Docket Item # 19 & 20
BAR CASE # 2010-0190

BAR Meeting
July 21, 2010

ISSUE: Permit to Demolish and Certificate of Appropriateness for an Addition & Alterations

LOCATION: 1314 King Street

Figure 2. Rear and Side Elevations

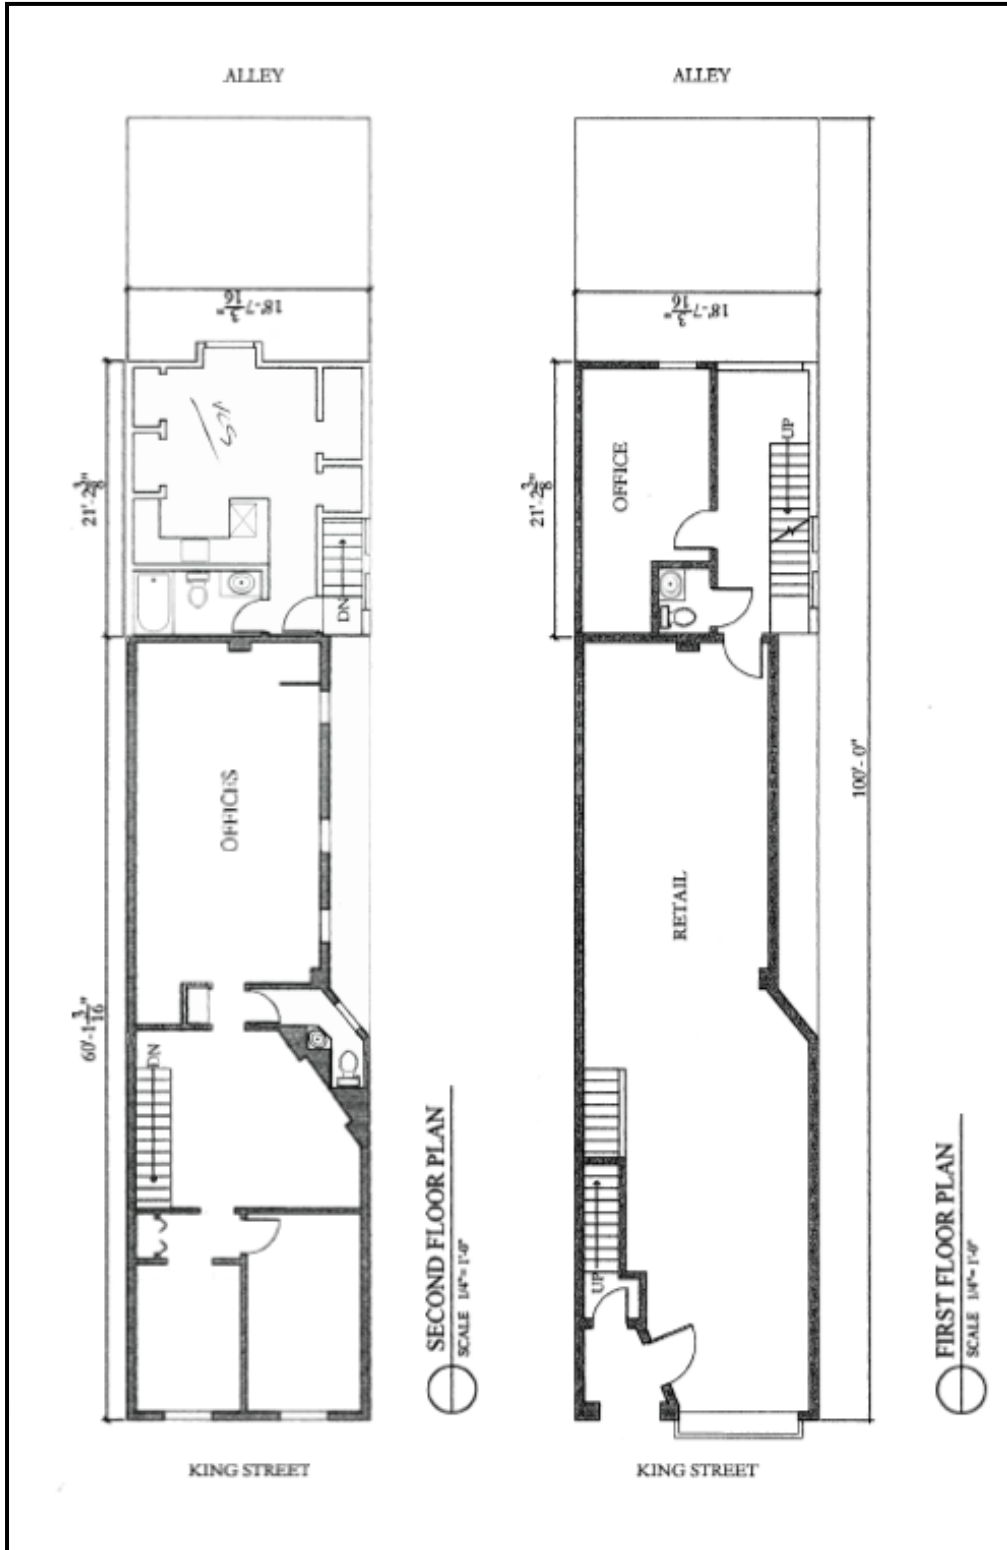
While staff sees the benefit of breaking up the addition's large west elevation with recessed panels, staff would prefer to see them be similar in shape and spacing to the openings on the historic building. Staff recommends that these minor modifications be reviewed and approved by staff prior to issuance of a building permit.

1. That the recessed panels on the west elevation be similar in shape and spacing to the openings on the original building, with Staff review and approval prior to issuance of a building permit.
